Access Compliance Report

Public Rights-of-Way

(Curb Ramps)

Intersection ID: 12704	Main Street: E_5TH_ST	Cross Street: N_DAVIDSON_ST	Location: E
ADA ID: 2F346303809D	Ramp Type: PerpDiag	Initial Pass/Fail: Fail	Overall Compliance: No
		Severity Score: 25

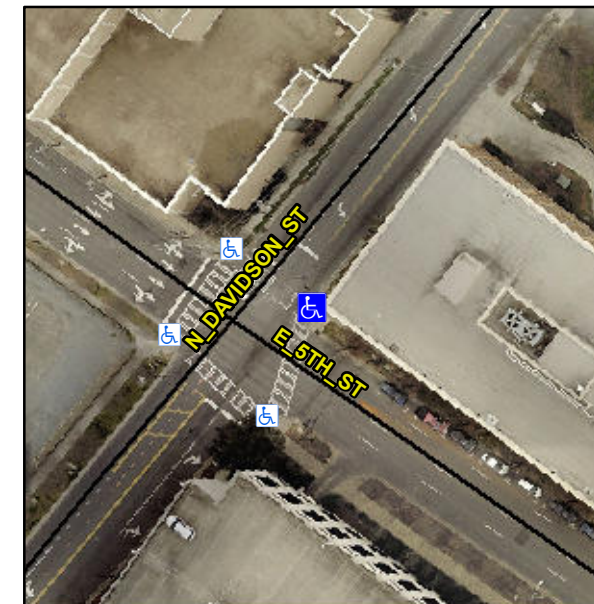
Remove & Replace Curb Ramp With Two New Directional Ramps or Equivalent.

Not Found, R304.2.2
